Docket Item #13
BAR CASE #2004-0205

BAR Meeting
October 6, 2004

ISSUE: Addition & alterations

LOCATION: 405 Green Street

Figure 3 - Rear elevation

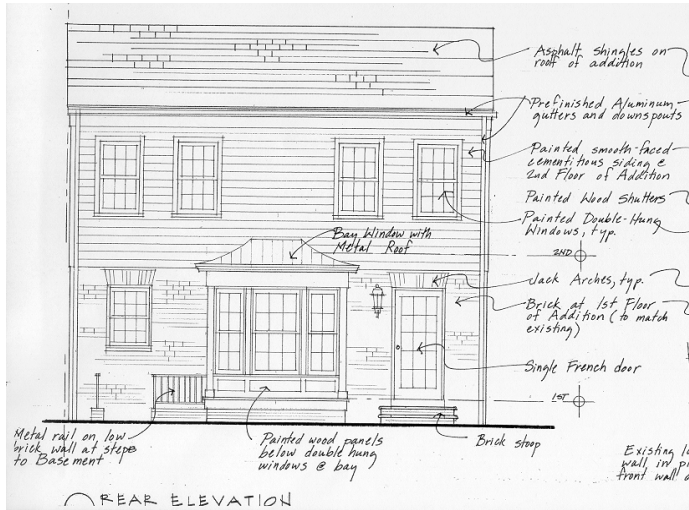
The rear (north) elevation will have a bay window in the center of the first story. The bay will have a six-over-six window in the center flanked by narrower four-over-four windows. There will be painted wood panels below each window and a metal roof. To the right side of the bay window there will be a single french door with multiple lights. It will have a brick stoop, a jack arch header and a carriage lamp light fixture to the side. On the left of the bay will be a small window above the areaway to the basement. The areaway will be surrounded by a low brick wall and simple metal railing. The second story will have four identical windows grouped to the right and left. The east side wall of the addition, which is on the property line, will have a pair of fake closed shutters at the second story with jack arch above and a fake roof vent in the attic level.

Figure 1 - Front elevation

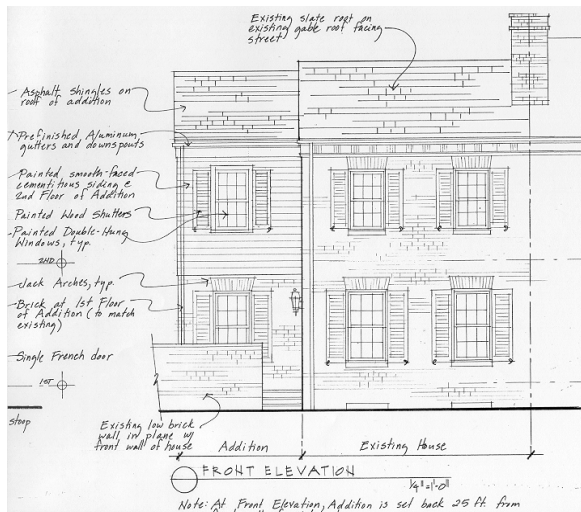
The (front) south elevation of the addition will have a window in the first and second story. The windows in the brick first story will have jack arches. Both windows will have louvered wood shutters.

Figure 2 - West side elevation

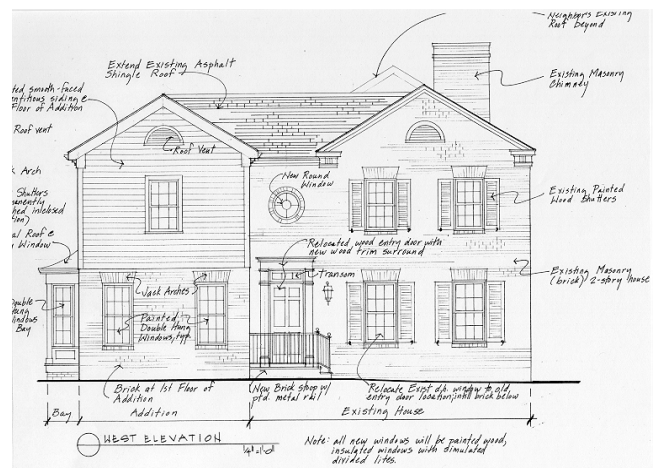
The west side elevation of the addition will have two windows on the first story. These will have jack arches and brick soldier course sills. There will be a single window centered in the second story. These windows will not have shutters. There will be a semi-circular roof vent in the attic of the gable.

The alterations to the existing house are generally confined to the back of the west elevation. The main entrance to the house is on the west side. This door will be shifted approximately 8' further north to a portion of the existing west side wall that is currently blank. The wood six-panel door will be reused within a new wood

surround and transom. The entranceway will have a brick stoop with simple painted metal railing and a carriage lamp. There will be a new round window in the second story centered above the new entranceway and located in what is now a blank section of the existing west wall. The existing entrance opening will be partially infilled with brick to become a window opening. One of the windows from the areas to be demolished will be inserted in this opening. The new window will have a jack arch and shutters to match the existing west side windows.
